2021-2023MY
Sorento (MQ4a)

257

TECHNICAL SERVICE BULLETIN

ITM REPLACEMENT AND ECM & TCM
LOGIC IMPROVEMENT (CA2508)

Flowchart: 2.5L GDI (Naturally Aspirated)

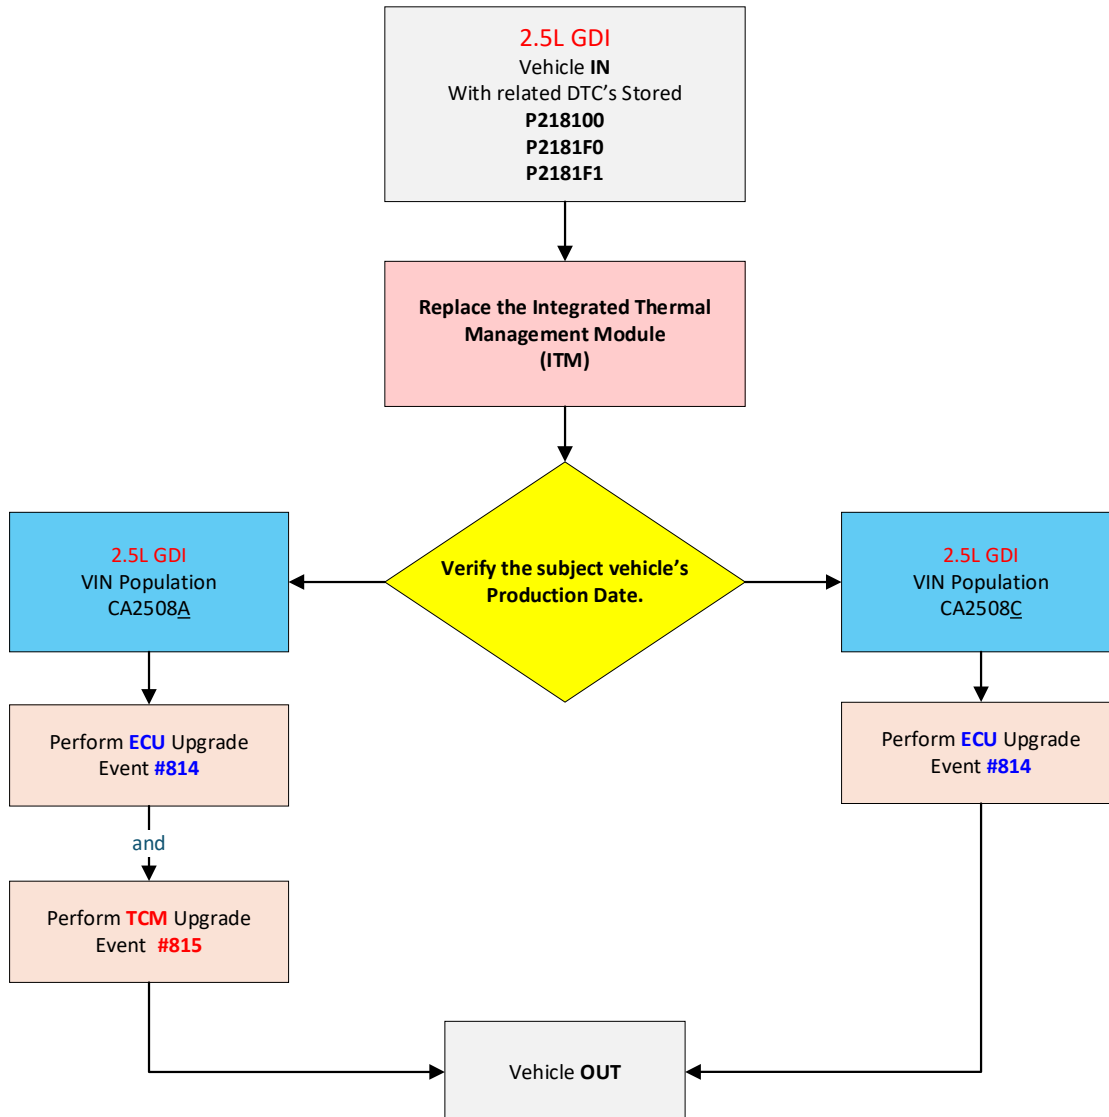
Perform the following software upgrade(s) in Auto Mode.

ENGINE	VIN LIST	SW #814	SW #815
2.5L GDI (Naturally Aspirated)	A	Yes	Yes
	C	Yes	N/A

ITM REPLACEMENT AND ECM & TCM LOGIC IMPROVEMENT (CA2508)**Flowchart: 2.5L T-GDI (Turbo)****❶ IMPORTANT**

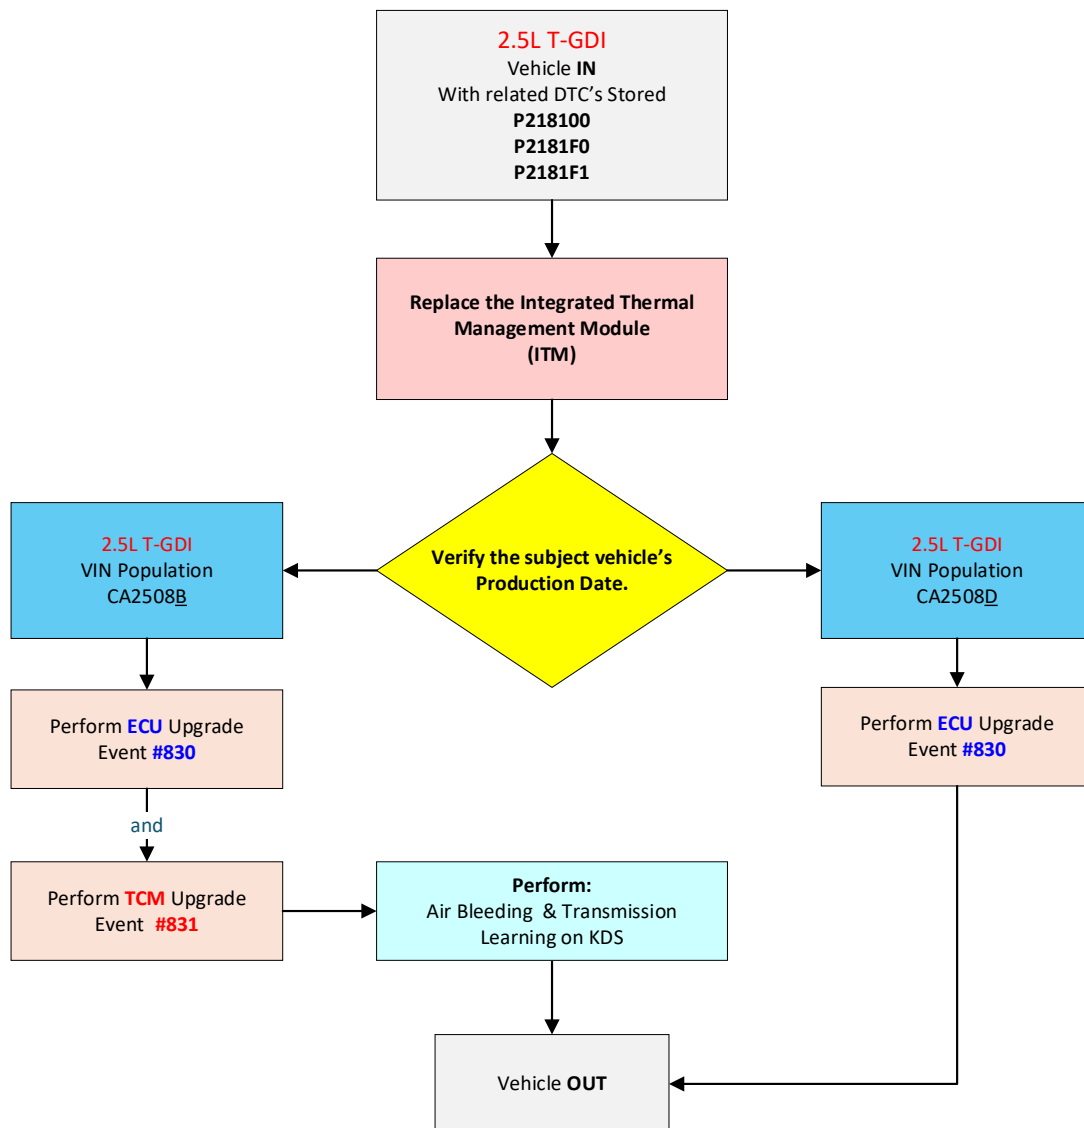
Perform the following software upgrade(s) in Auto Mode.

ENGINE	VIN LIST	SW #830	SW #831	Air Bleed Learning	Transmission Learning
2.5L T-GDI (Turbo)	B	Yes	Yes	Yes	Yes
	D	Yes	N/A	N/A	N/A

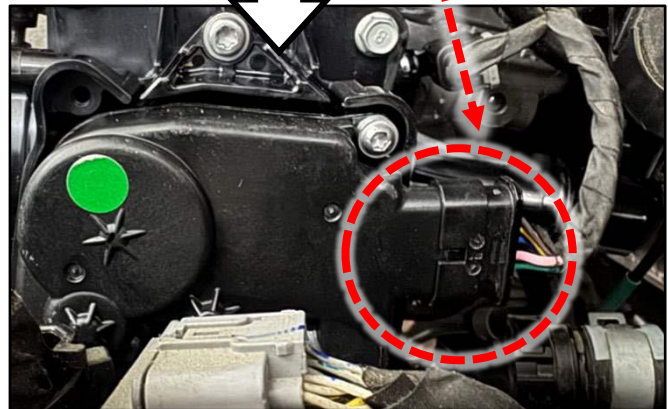
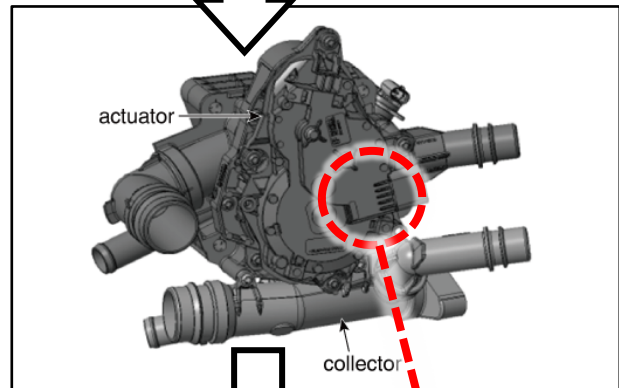
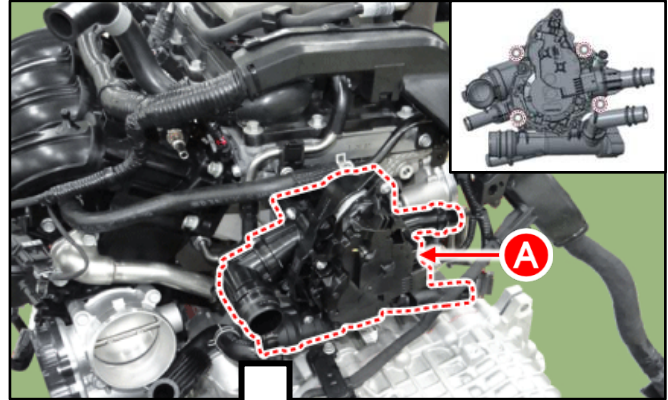
1. Replace the Integrated Thermal Management Module 'ITM' (A) by referring to "Engine Mechanical System → Cooling System → Integrated Thermal Management Module (ITM) → Repair procedures" in the applicable Shop Manual on KGIS.

Tightening torque for bolts:
7.2 - 8.7 lb.ft (9.8 - 11.8 N.m)

Do NOT dismantle the actuator and collector. The new ITM is supplied as and assembly unit.

Note: The ITM connection orientation changes after replacing the new ITM part. The locking tab will face the engine.

Trying to make the connection on the new ITM in the same orientation as the original ITM may damage the connector pins/terminals.
